LEONA SUBDIVISION

APPLICATION NUMBER 16 DATE August 6, 2015

REQUEST Subdivision

DETAIL SITE PLAN

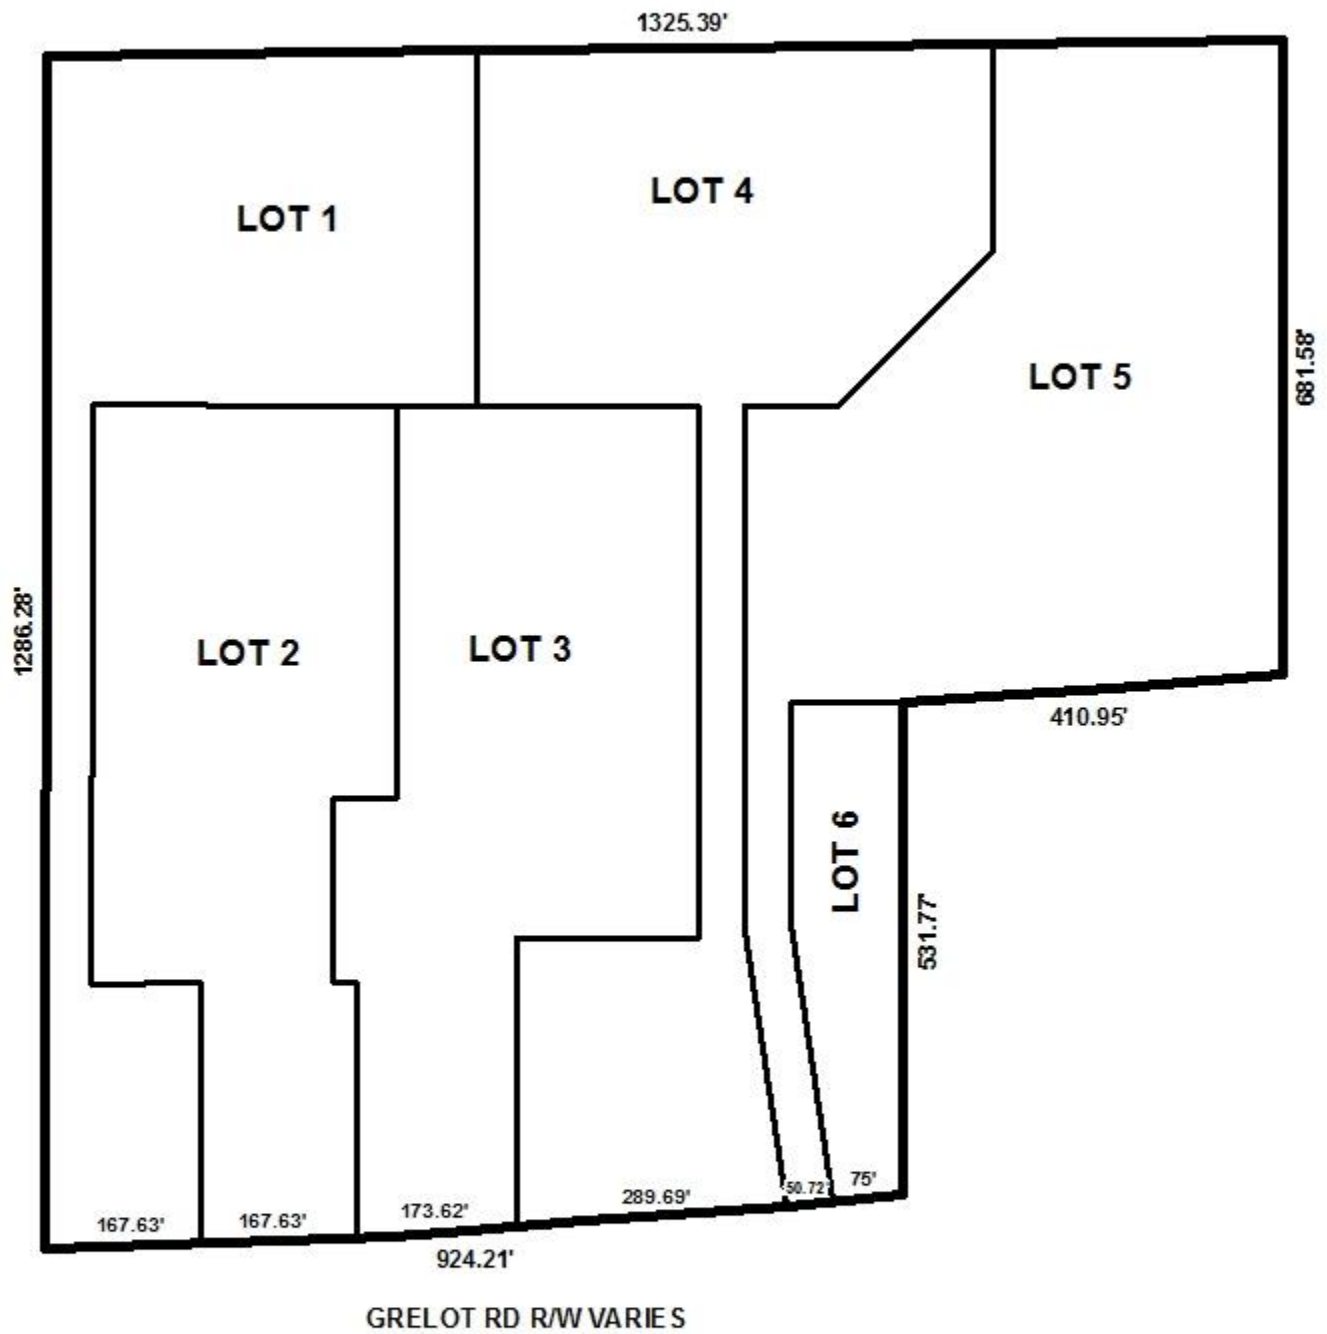
The proposed lots appear to meet the minimum size and frontage requirements as regulated by Section V.D.2. of the Subdivision Regulations. However, the lots do not comply with Section V.D.3. of the Subdivision Regulations regarding the maximum width to depth ratio. Thus, a waiver of Section V.D.3 will be required in order to approve the subdivision as proposed.

As proposed, Lots 1-5 are considered to be a “flag” lots, although the frontage widths range from 50.72’ to 290’ ±. Section V.D.1. of the Subdivision Regulations does not allow flag lots unless such are common within the area, or in the case of a family division of property. The application included a letter indicating that the 6 lot subdivision is indeed a family subdivision. The applicant states following: *“This is a family subdivision and the reason we are subdividing the land this way is because all parcels would connect to Grelot Road. Because the property was left to us in this order. We have houses on some of it and we tried to connect it with our other part”*. A waiver of Section V.D.1. of the Subdivision Regulations will be required, if approved. A note should also be placed on the Final Plat, stating that no future subdivision of Lots 1 through 6 is allowed until adequate frontage on a compliant public or private street is provided.

The proposed lots have frontage along Grelot Road, a major street with a 100’ right-of-way as shown on the Major Street Plan Component of the Comprehensive Plan. The preliminary plat

currently depicts the right-of-way width as variable; therefore the dedication of any necessary right-of-way to provide 50' from the centerline of Grelot Road will be required if the right-of-way is less than 100' in width.

As a means of access management, a note should be placed on the Final Plat limiting each lot to one curb-cut to Grelot Road with the size, design, and location of all curb-cuts to be approved by Mobile County Engineering and conform to AASHTO standards.

The 25' minimum building setback line as required by Section V.D.9. of the Subdivision Regulations is not depicted on the preliminary plat. The 25' minimum building setback line should be depicted on the Final Plat, if approved, where each lot is a minimum of 60' in width.

The lot sizes are labeled in square feet and acres. If approved, the lot sizes in square feet and acres should be retained on the Final Plat, (revised for any required dedication) or the furnishing of a table providing the same information will be required.

With a waiver of Sections V.D.1. and V.D.3 of the Subdivision Regulations, the application is recommended for Tentative Approval, subject to the following conditions:

- 1) revision of the plat to depict the right-of-way width of Grelot Road and provide dedication if needed to provide 50' as measured from the centerline;

- 2) revision of the plat to depict the 25' minimum building setback lines where each lot is 60' in width;
- 3) placement of a note on the Final Plat stating that each lot is limited to one curb-cut to Grelot Road, with the size, design and locations to be approved by Mobile County Engineering Department and conform to AASHTO standards;

- 4) retention of the labeling of the lots in square feet and acres, (revised for any dedication) or the furnishing of a table on the Final Plat providing the same information;

- 5) placement of a note on the Final Plat stating that there shall be no future subdivision of Lots 1 through 6 until adequate frontage on a compliant public or private street is provided;

- 6) placement of a note on the Final Plat stating that any lots which are developed commercially and adjoin residentially developed property must provide a buffer, in compliance with Section V.A.8. of the Subdivision Regulations;

- 7) placement of a note on the Final Plat stating that development will be designed to comply with the stormwater detention and drainage facilities of the City of Mobile stormwater and flood control ordinances, and requiring submission of certification from a licensed engineer certifying that the design complies with the stormwater detention and drainage facilities of the City of Mobile stormwater and flood control ordinances prior to the issuance of any permits. Certification to be submitted to the Planning Section of Urban Development and County Engineering;
